PHILADELPHIA ELECTRIC COMPANY

SUBJECT: Limerick Generating Station, Units 1 & 2  
Additional Information for Auxiliary Systems  
Branch Regarding SER Open Issue #2 (Tornado  
Missile Effects on Ultimate Heat Sink)

RESPONSES TO QUESTIONS AND REQUESTS FOR  
ADDITIONAL INFORMATION ON  
NUS-4507 REPORT

"LIMERICK GENERATING STATION UHS EXTREME WIND HAZARD ANALYSIS"

Figure 1. Comparison of TORMIS and NRC hazard curves.

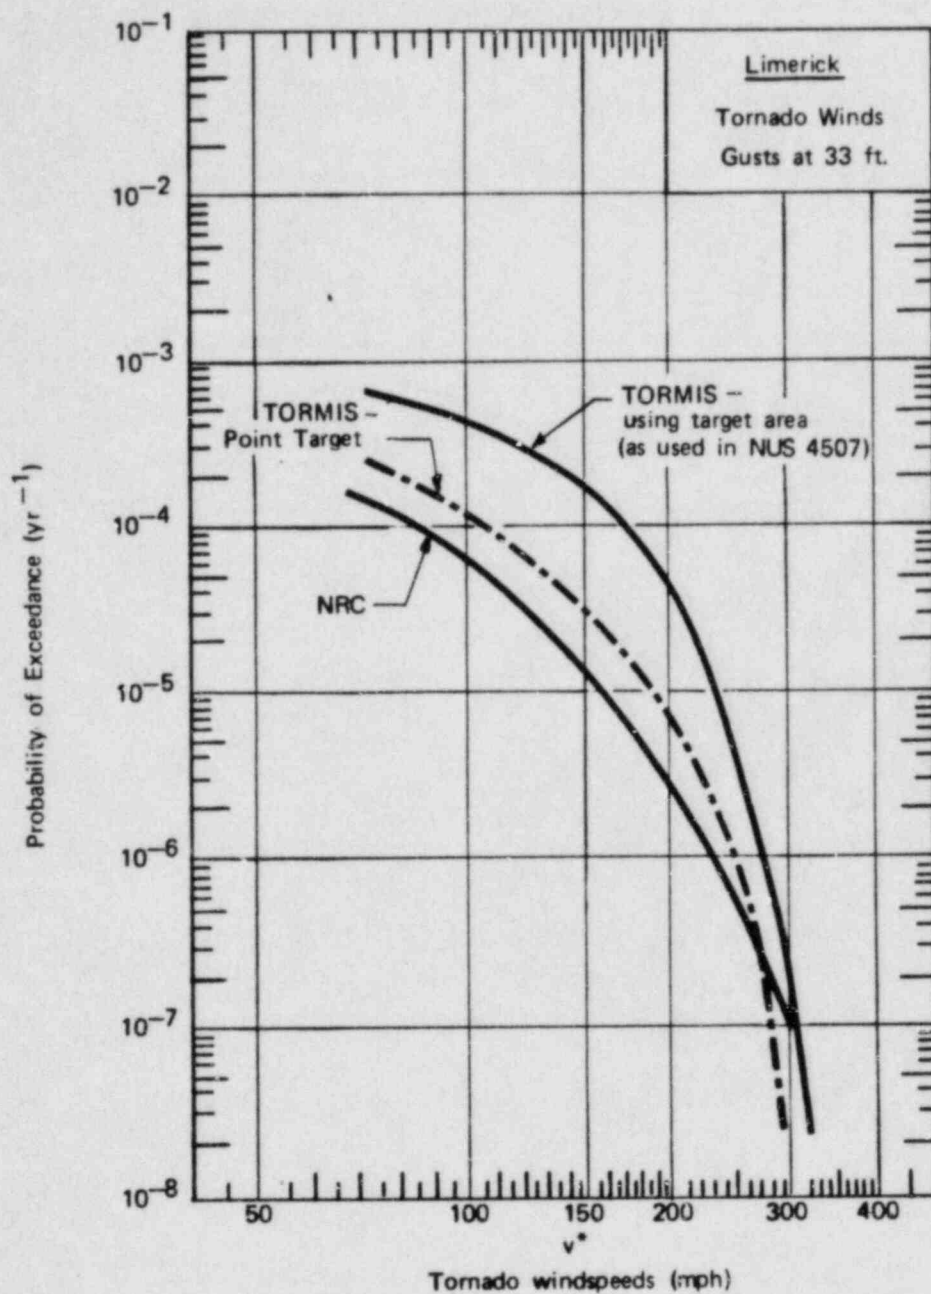
Q1. Document the basis for concluding that the analysis is a conservative, rather than a realistic one. The discussion should address all stages of the analysis presented in the NUS report. It is requested in particular, that the conservatisms associated with the tornado characteristics of length, width, and gradation of intensity within the path, and the treatment of the uncertainties in those characteristics, be addressed.

A quantitative demonstration of the conservatisms in the analysis and an overall test of the tornado hazard model can be obtained from comparison of results to those of other models; in particular, the NRC developed hazard curve (Ref. 22) for Limerick. Figure 1 compares the tornado hazard curve developed using the TORMIS methodology (Figure 3-3a of NUS-4507, Ref. 23) with the NRC curve. The curve used in the Limerick tornado wind and missile analysis represents the frequency with which the windspeed at any point on the target exceeds the specified velocity is very conservative relative to the NRC curve over the entire range of windspeeds of concern. The curve is a factor of 7 to 10 more conservative than the NRC curve for speeds less than about 260 mph. Hence, on the basis of this quantitative comparison, the TORMIS tornado hazard methodology and results for the Limerick analysis are conservative. Had the NRC curve been used in the Limerick UHS analysis, the F4 tornado contribution to the failure criteria would have been a factor of 10 less and the F5 contribution a factor of 2 less. The final results in the NUS-4507 (Ref. 23) would then be:

<u>As Reported</u> <u>TORMIS Hazard Curve</u>	<u>Updated with</u> <u>NRC Hazard Curve</u>
Event T	$6.6 \times 10^{-7}$	$8.2 \times 10^{-8}$
Event V	$7.9 \times 10^{-7}$	$1.1 \times 10^{-7}$

In summary, the tornado hazard curve used in NUS-4507 is very conservative relative to the NRC curve which was developed using different assumptions but which is also believed to be conservative.

Figure 2. Points at which Horizontal Windspeeds Were Calculated

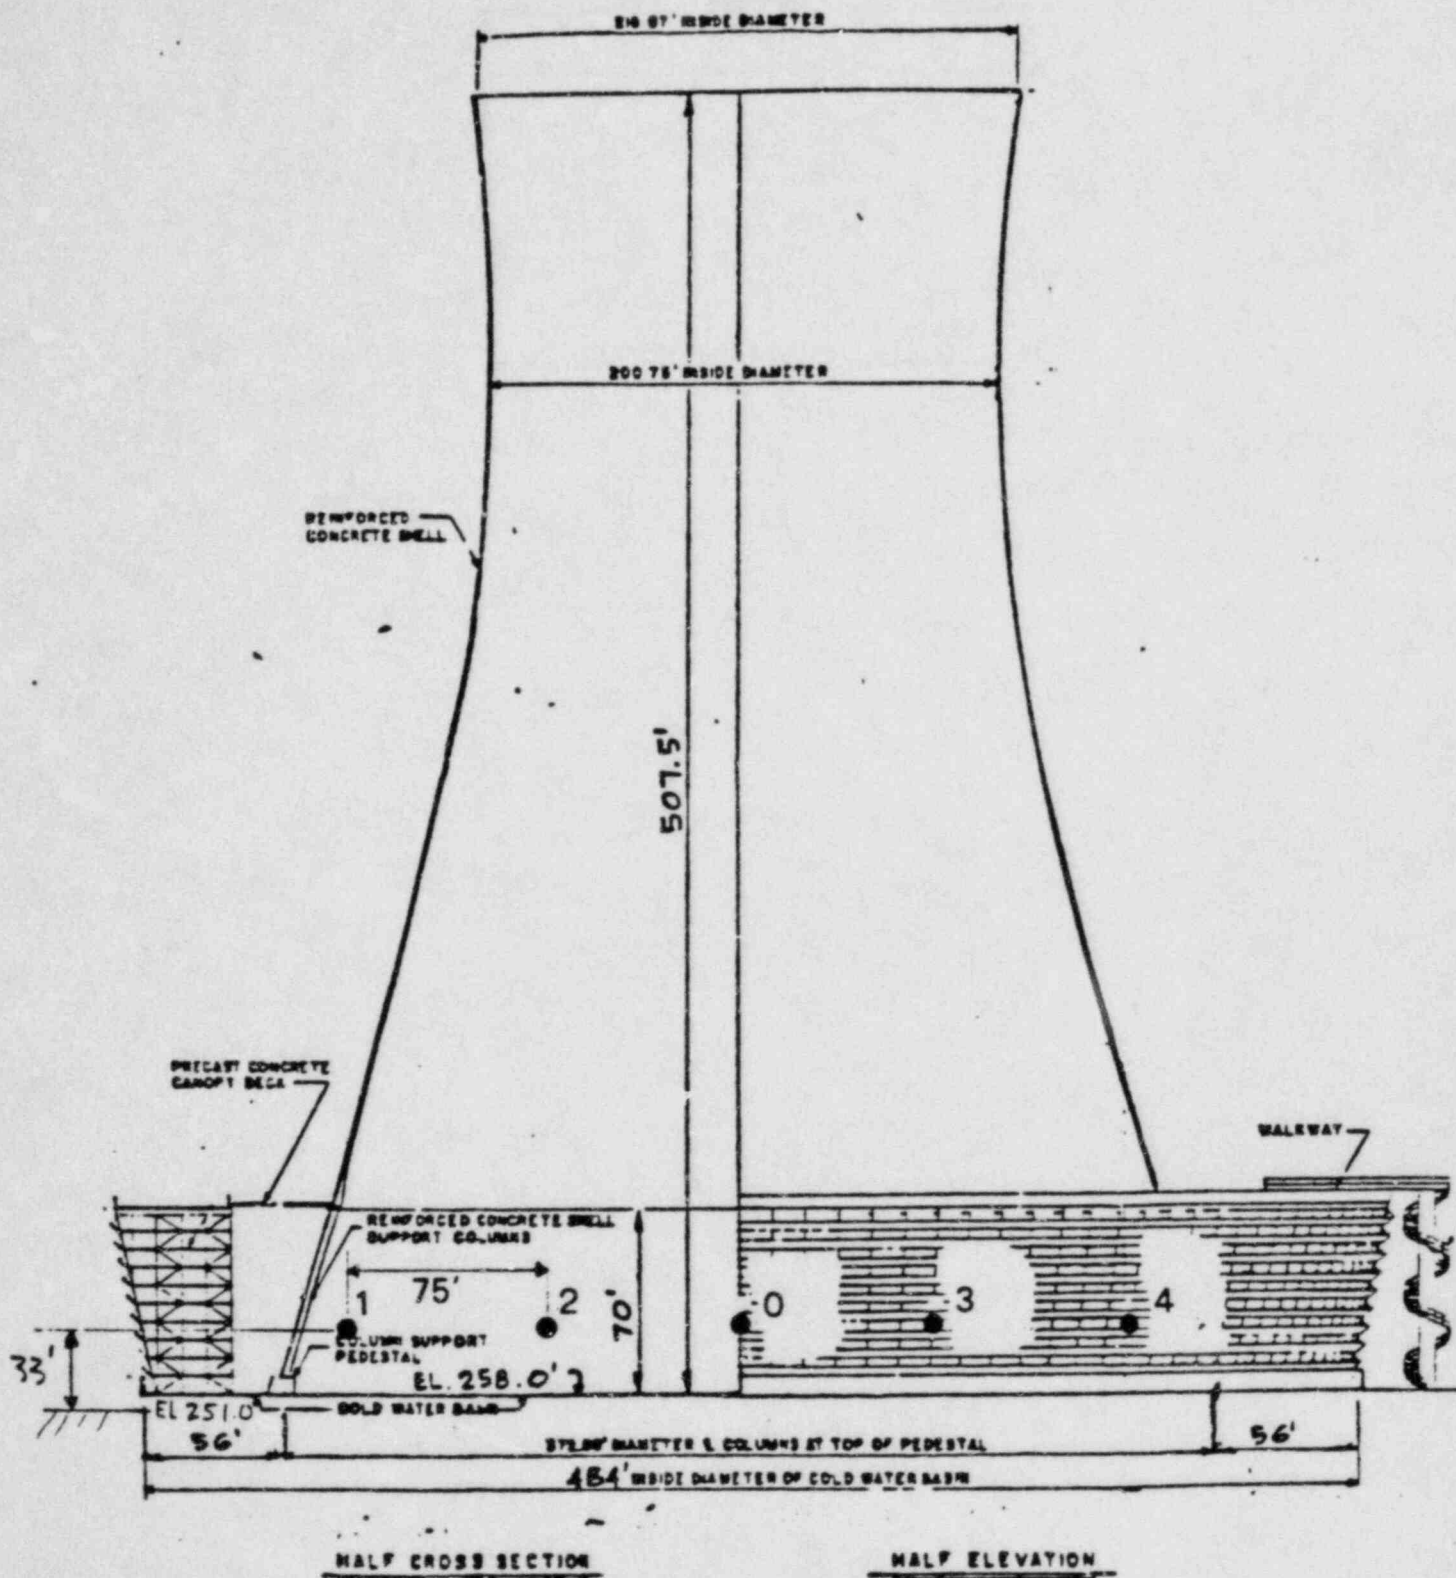
Q3. The failure criterion adopted for the cooling towers is that the cooling towers fail if the windspeed exceeds 140 mph at the center of the tower, at mid-height. It is possible that a portion of the tower can experience wind speeds in excess of 140 mph while the center of the tower does not. Discuss the significance of this with respect to any potential lack of conservatism, that is, should the 140 mph windspeeds just touching the tower be the conservative failure criterion?

- a. What is the chance that a part of the tower sees winds greater than 135 mph, given that the center experiences winds less than 135 mph?
- b. How important are local pressure variations in height and width relative to the expected mode of tower failure in tornadoes?

In order to assess the likelihood that some part of the cooling tower might experience winds in excess of 135 mph at 33 ft elevation when the windspeed at the center is less than 135 mph,  $P(V_m \geq 135 | V_0 \leq 135)$ , a TORMIS simulation was performed with additional check points on windspeed exceedance. As shown in Figure 2 five points were chosen at 75 ft spacing and 33 ft elevation in a vertical plane containing the center line of the tower and normal to the tornado direction of travel. One thousand tornadoes were simulated in each of the F2-F5 intensity levels and the maximum horizontal windspeed  $V_0$  at tower center (point 0) on each cooling tower for each tornado was calculated. For each tornado for which  $V_0$  did not exceed 135 mph, the maximum windspeeds,  $V_1$  through  $V_4$ , at the other points were calculated. Letting  $V_m$  be the maximum of these ( $V_m = \max\{V_i\}$ ,  $i = 1, 2, 3, 4$ ) the scoring of one of seven mutually exclusive and collectively exhaustive events was as follows:

Table 6 summarizes these results. They indicate that only 3, 12, 14, and 14 percent of F2, F3, F4, and F5 tornadoes, respectively, would produce winds in excess of 135 mph on the tower given that the center of tower experience winds  $\leq 135$  mph. For  $V_m$  to significantly exceed 135 mph, say  $V_m \geq 165$  mph, these probabilities are 0, 0.04, 0.08, and 0.07, respectively. Hence, these results indicate that the error introduced by using tower center point is not significant, considering the other conservatisms in the analysis.

Figure 4. TORMIS Tornado Wind Profile Corresponding to Tower Failure

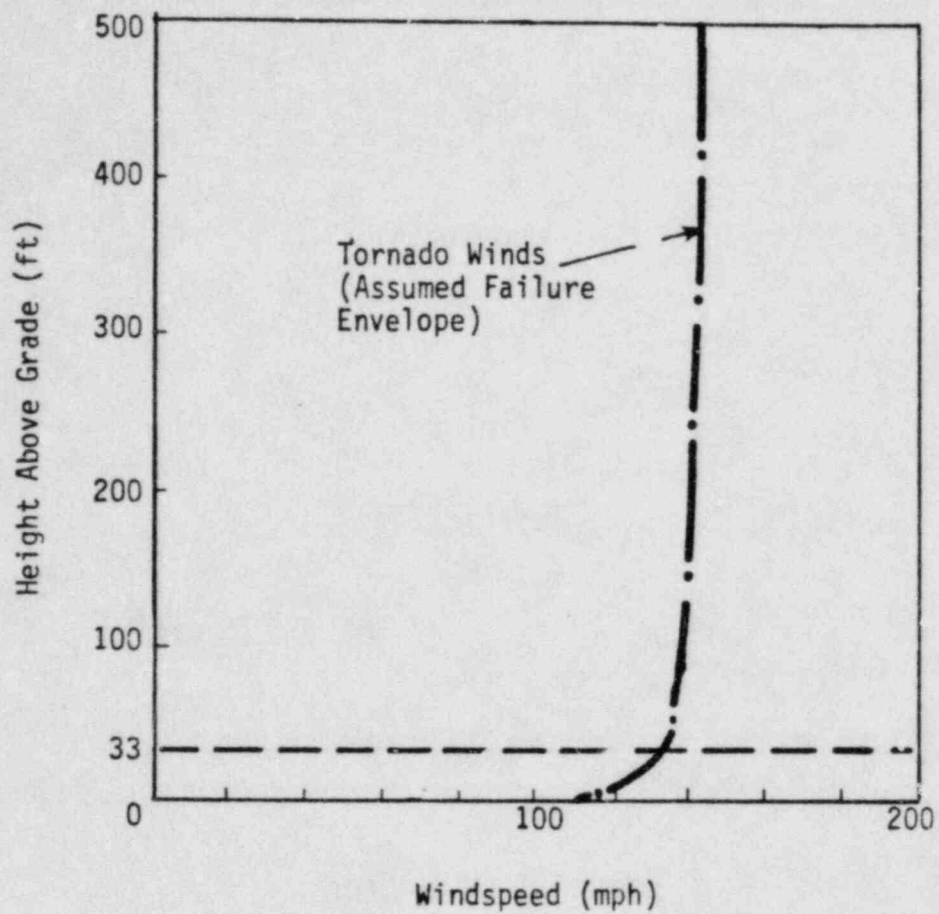
Q5. What is the value of the tornado wind speed at an elevation of 33 ft which corresponds to the nominal failure of the cooling towers? Are the results of the simulations in the NJS report compatible with these values?

NUS-4507 reported a tower failure speed of 140 mph at tower midheight. This speed, on the basis of published TORMIS wind profiles (2), is consistent with the 135 mph at 33 ft and was reported on that basis. Figure 4 illustrates this profile variation of tornado windspeed with height. The midheight speed was reported since it was felt that midheight was a more useful engineering reference than 33 ft for towers of 500 ft height. Considering the practical aspects of predicting tower failure, the TORMIS tornado wind profile can be treated as essentially uniform above 33 ft.

Thus, it has been concluded that maximum horizontal windspeeds at tower midheight would generally be between 134 and 142 mph when the maximum windspeeds at 33 ft were 135 mph. The results reported in NUS-4507 are consistent with these values.
